SECTION 00 91 15

ADDENDUM NUMBER 6

- 1.01 DATE: APRIL 6, 2021**
- 1.02 PROJECT: WELCOME CENTER**
- 1.03 PROJECT NUMBER: DCM NO. 2020604**
- 1.04 OWNER: ALABAMA A&M UNIVERSITY**
- 1.05 ARCHITECT: NOLA | VAN PEURSEM ARCHITECTS, PC**

SHEET NUMBER
A-5.5
OF

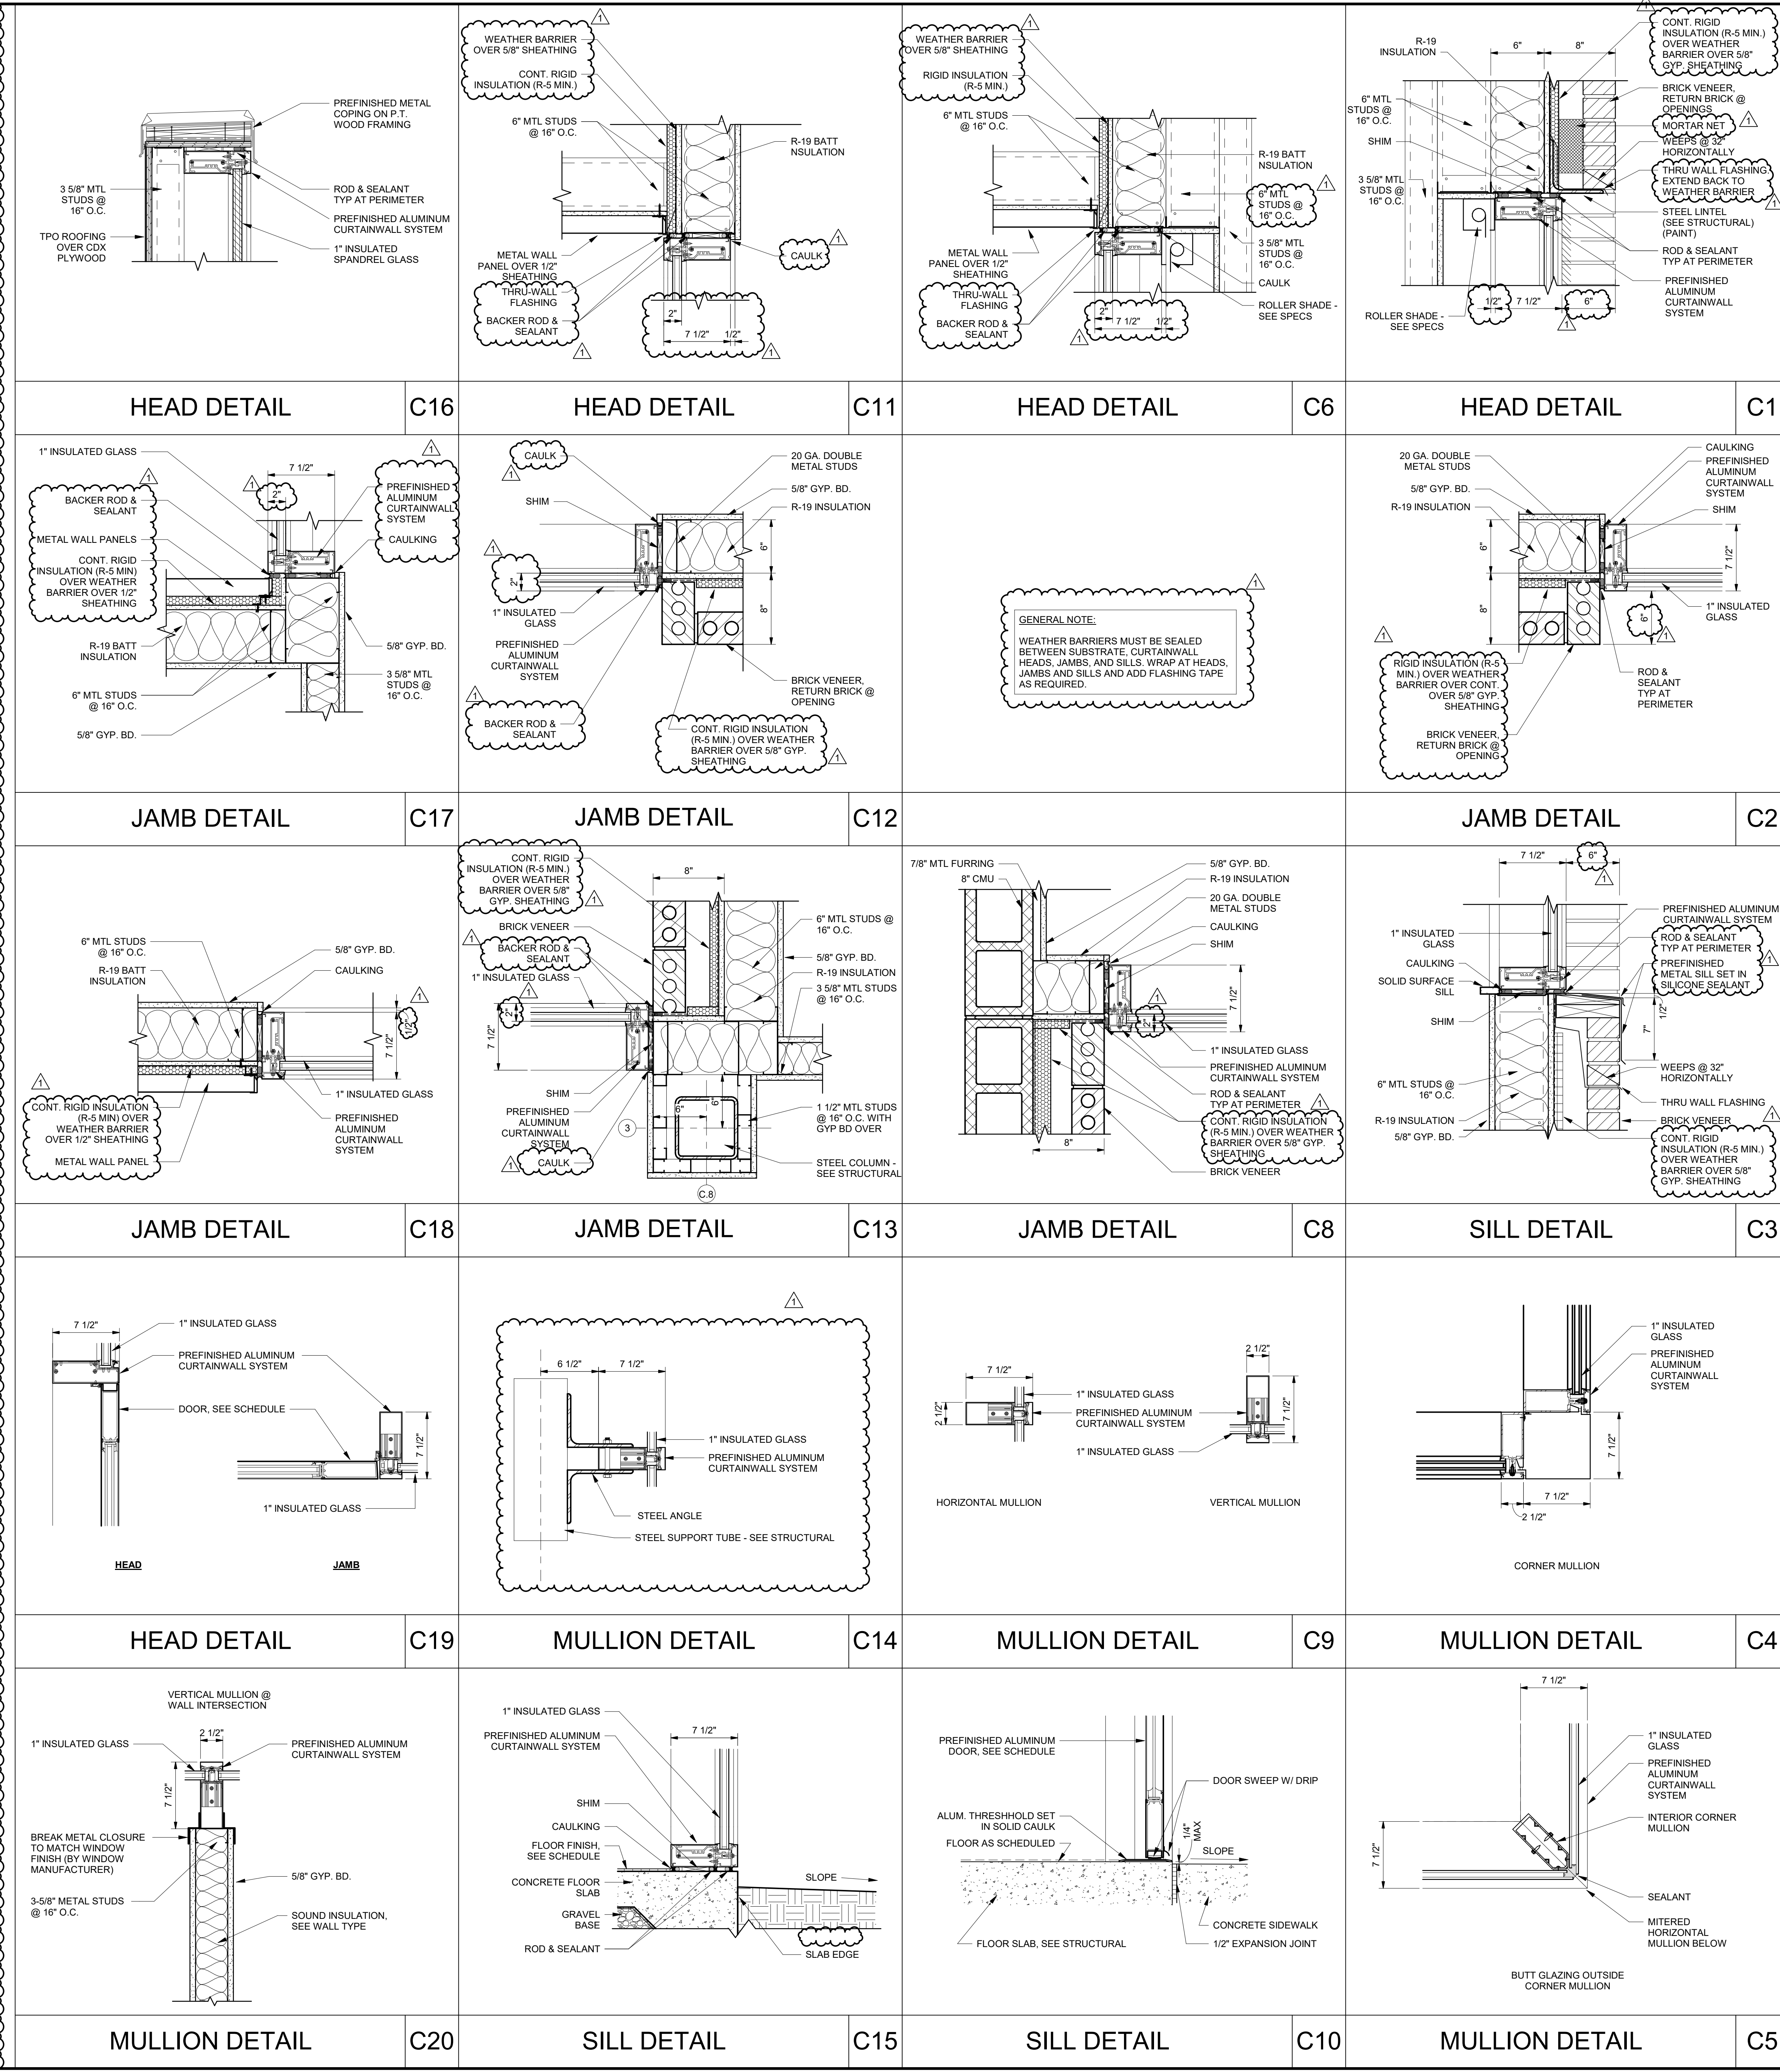
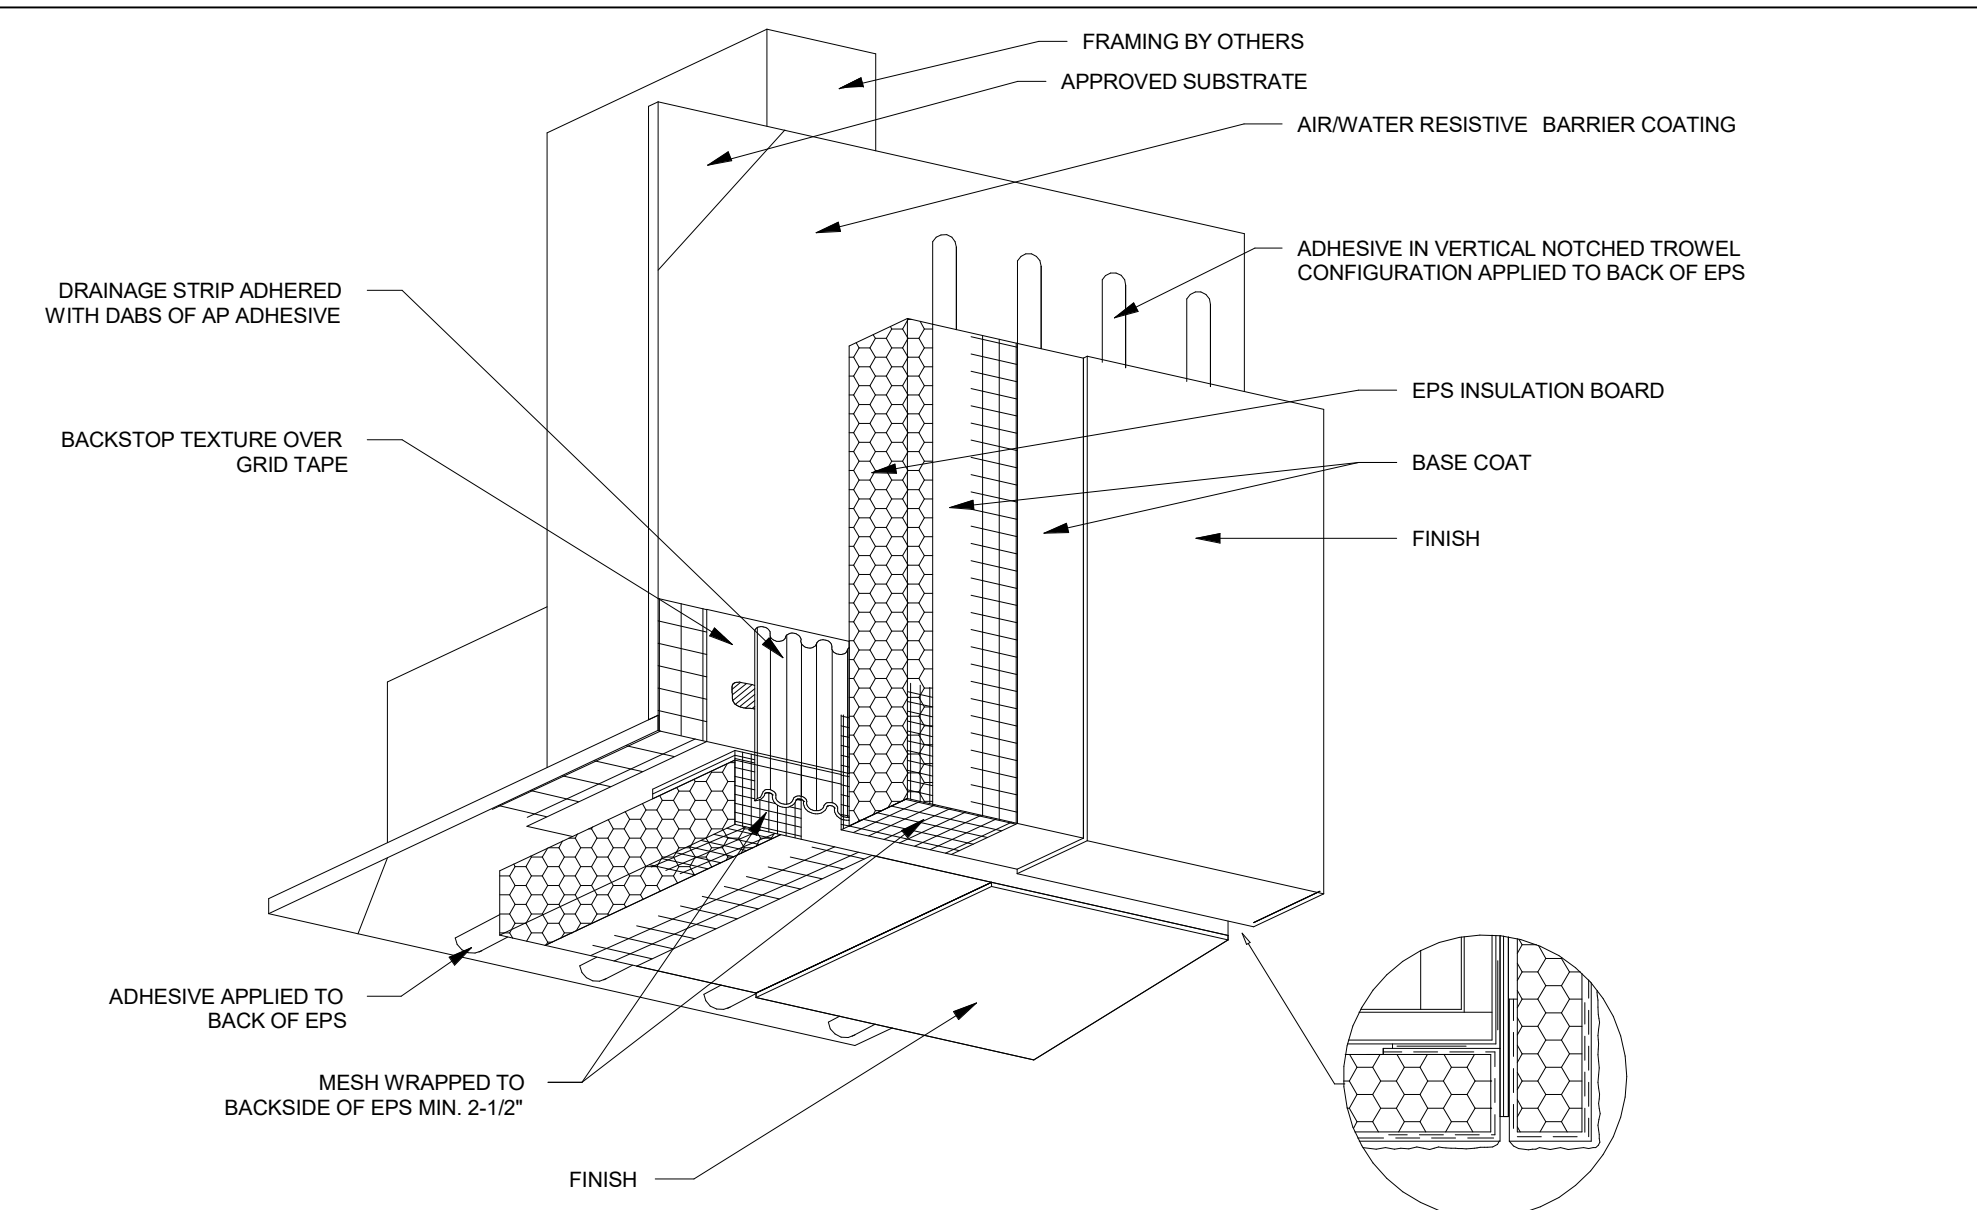
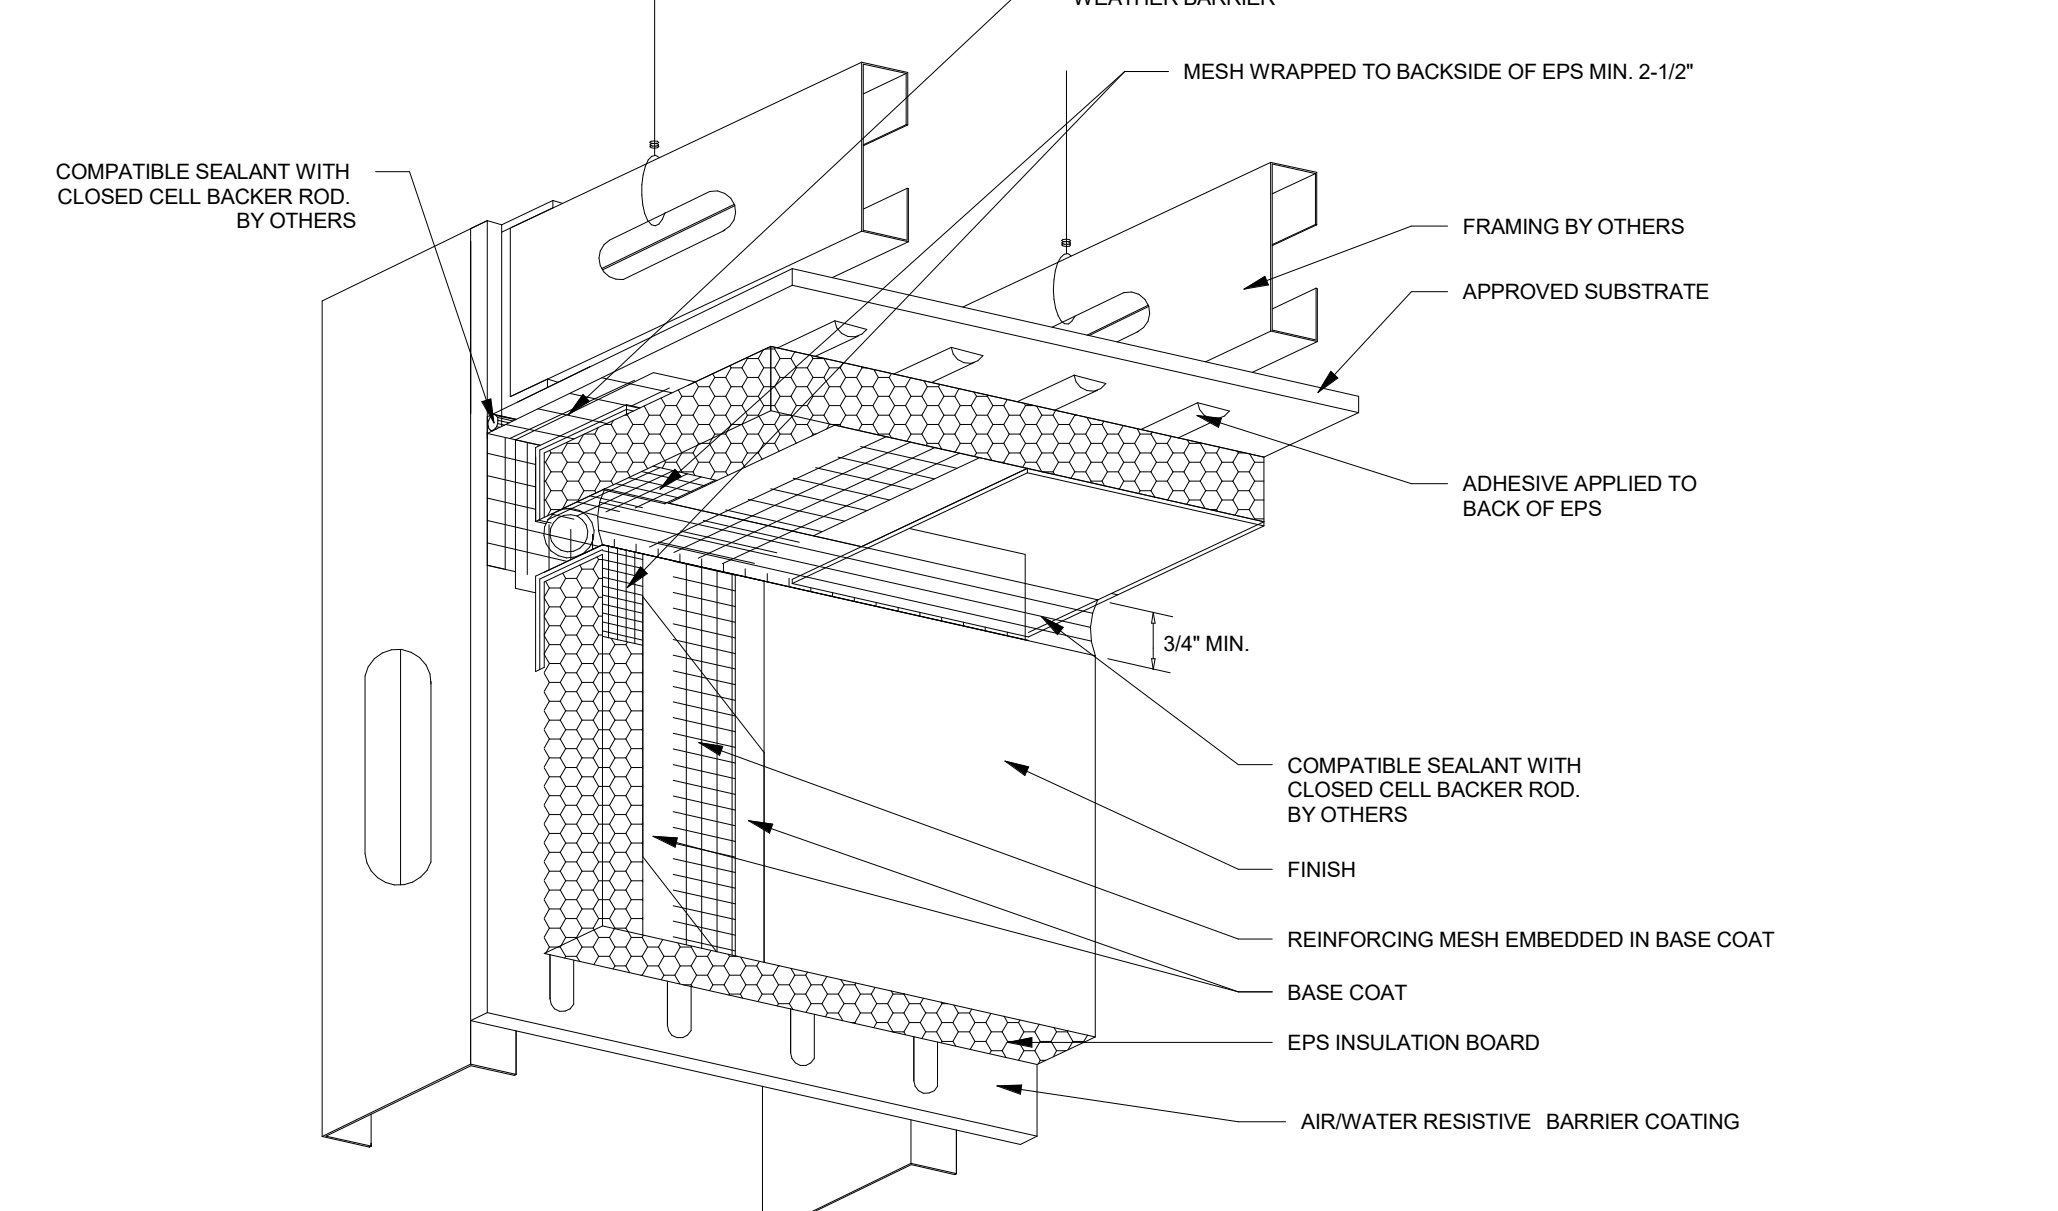
4.12 SHEET A-5.5 – CURTAINWALL DETAILS:

- A. Replace this sheet in its entirety. Revisions include the following:
1. Adjusted dimensions and notes on curtain wall details.
 2. Added EIFS details.
